P 517946

ON-SITE SEWAGE DISPOSAL SYSTEM HOWARD COUNTY HEALTH DEPARTMENT BUREAU OF ENVIRONMENTAL HEALTH

ADDRESS: 8450 Church Lane PROPERTY OWNER: Eric Johnson

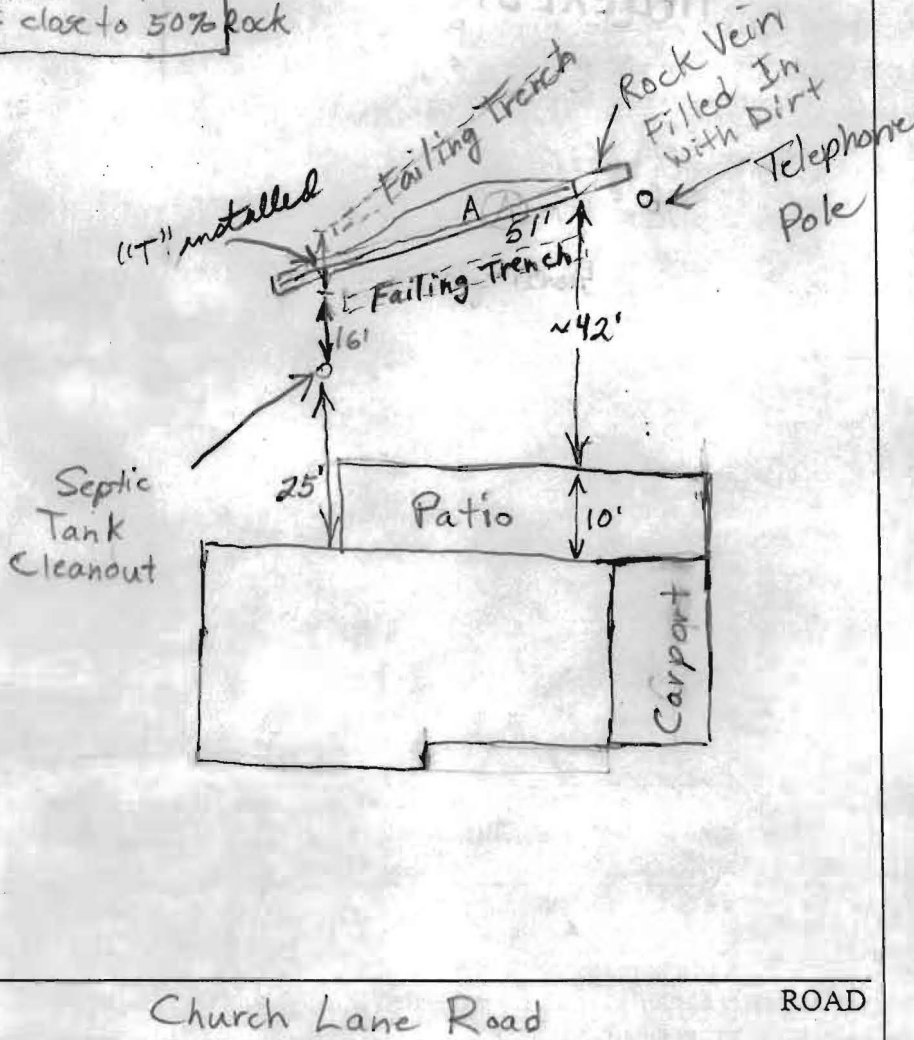
PRE-CONSTRUCTION 10/3/02 To install a 55' trench with stone from 3.5'-10.0'. Trench to be 3' wide. Existing failing installation trenches to be disconnected.

10/3/02 Hit rock vein when digging trench. Told contractor to backfill rock vein with dirt and extend trench in opposite direction. O.K. to install T in trench. 10/3/02 Trench caved in according to contractor. Parts of trench now 8' wide. Not enough stone to fill entire trench to 3.5' (contractor said he dug out caved in dirt). Stone now 3.5' deep in upper part of trench and 5' deep in

cave-in. O.K. to cover. (BB)
